ORIGINATION FORM

Proposed Revisions to a Standard Plans Index
(Please provide all information — Incomplete forms will be returned)

Index Number: 649-031
Sheet Number (s): 2 of 6
Index Title: MAST ARM ASSEMBLIES

SECTION A-A

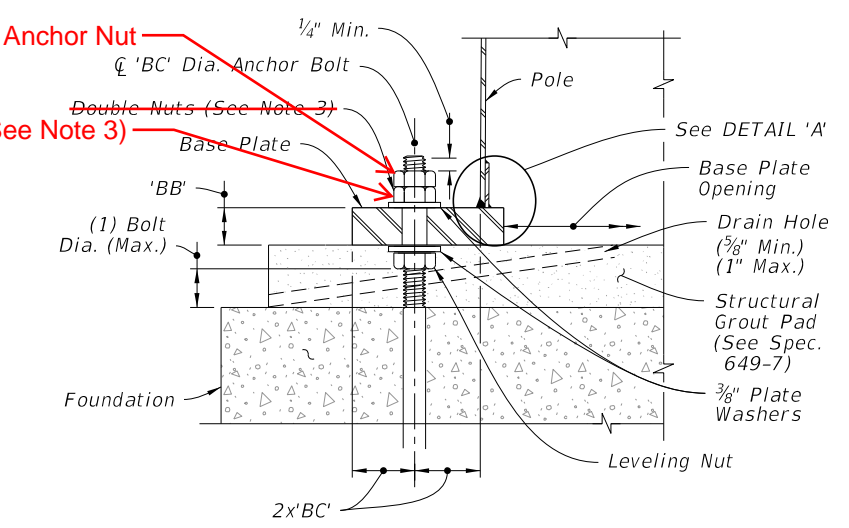
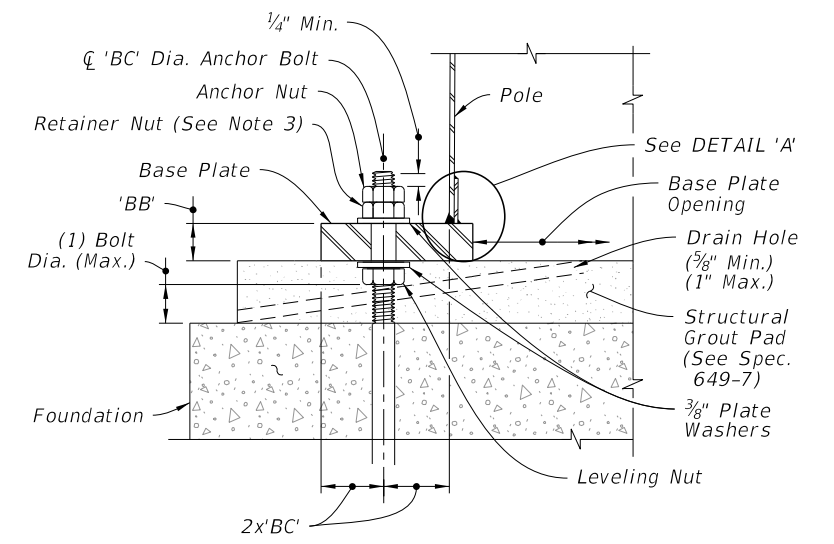
Sheet 2: Changed Note 3 and revised Section A-A to add clarity to anchor bolt nuts.

Sheet 2: These changes were to add clarity, consistency, and specificity to the anchor bolt nuts.

- The Structural Grout Pad diameter may be reduced where the footprint of the Grout Pad does not provide adequate clearance for the sidewalk and/or accessibility considerations.
- See Index 649-030 and the plans for actual quantity of bolts in the Base Plate Connection.
- The ~~bottom hex nut of the Double Nuts~~ shown in Section A-A may be substituted by a half-height ~~anchor "jam" nut~~. Provide individual nut covers (not shown) for each bolt.
- Detail 'A' Silicone Caulk may be applied after installation. Consult with Manufacturer to determine the suitability of the caulk to be applied.

1. The Structural Grout Pad diameter may be reduced where the footprint of the Grout Pad does not provide adequate clearance for the sidewalk and/or accessibility considerations.
2. See Index 649-030 and the plans for actual quantity of bolts in the Base Plate Connection.
3. The retainer nut shown in Section A-A may be half-height. Provide individual nut covers (not shown) for each bolt.
4. Detail 'A' Silicone Caulk may be applied after installation. Consult with Manufacturer to determine the suitability of the caulk to be applied.
